Department of Transportation

MEMORANDUM

SUBJECT: BZA Case No. 19960 – 1400 Montana Avenue NE

Figure 1. Residential Building Entrance, Source: Exhibit 5 of the BZA Application

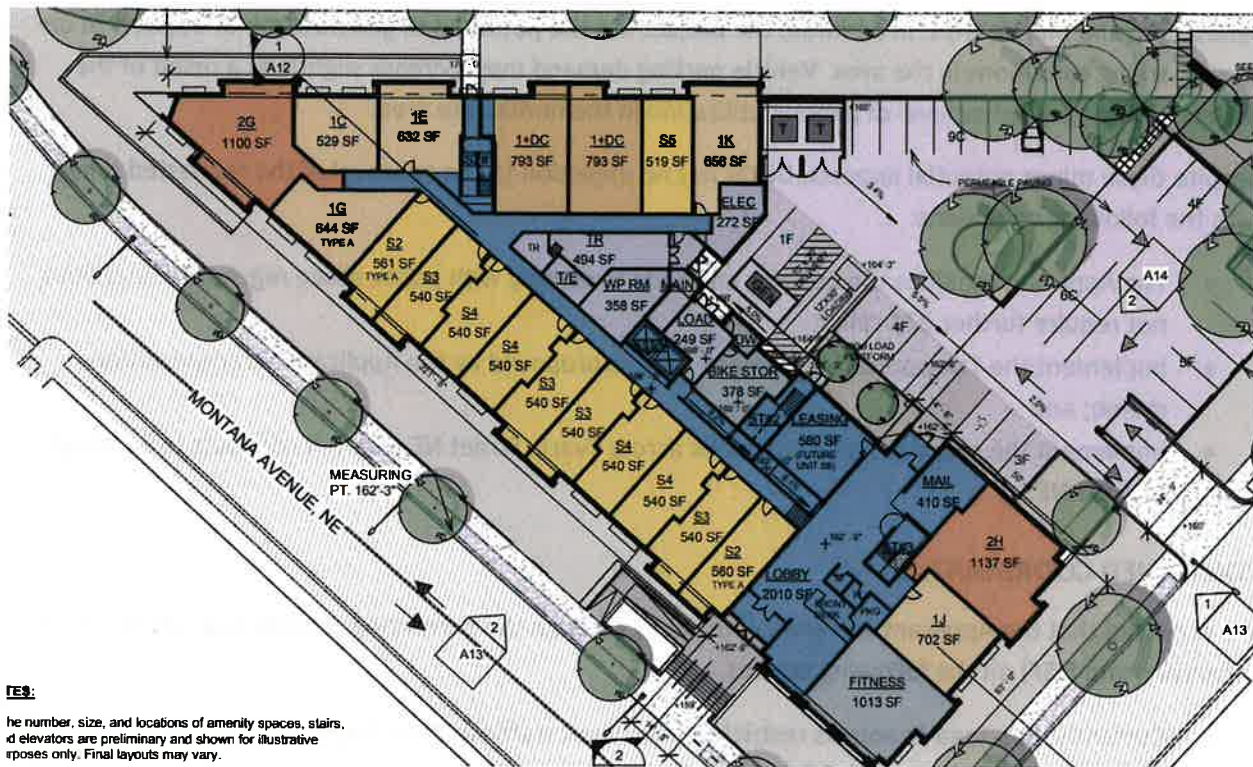
Pedestrian access is proposed from Montana Avenue NE through a building entrance that does not meet the public space regulations for step and ramp projections. The building entrance may impact the design of the building and relief requested to the BZA and will need revised before public space permitting. For new construction DDOT prefers at-grade entrances and if that is not possible the Applicant should design an entrance that complies with Public Space regulations. The Applicant was notified at the project scoping meeting that the ramp and step projections were not compliant and would need revised. The new proposed ramp and step projection still exceeds the requirement, 10-ft (DCMR 12-3202.11.3). Exhibit 5 shows ramping and stepping internal to the structure which suggests the portion of the building at the corner of Montana Avenue NE and Saratoga Avenue is artificially being raised thus impacting public space, as shown in Figure 1.

- The Applicant was notified at the project scoping meeting that the ramp and step projections were not compliant and would need revised;
 - The new proposed ramp and step projection still exceeds the requirement, 10-ft (DCMR 12-3202.11.3) and conflicts with the proposed bay window;

- Exhibit 5 shows ramping and stepping internal to the structure which suggests the portion of the building at the corner of Montana Avenue NE and Saratoga Avenue is artificially being raised thus impacting public space; and

- The building entrance may impact the design of the building and relief requested to the BZA and will need revised before public space permitting.
- Bay windows and areaways should comply with Section 3202 in DCMR Chapter 12.

- The Applicant modifies the building entrance to comply with public space regulations and does not require further BZA relief;
- Implement the Transportation Demand Plan as proposed by the Applicant's transportation memo; and
- Implement the proposed new crosswalk across Evarts Street NE where it connects to Saratoga Avenue NE.
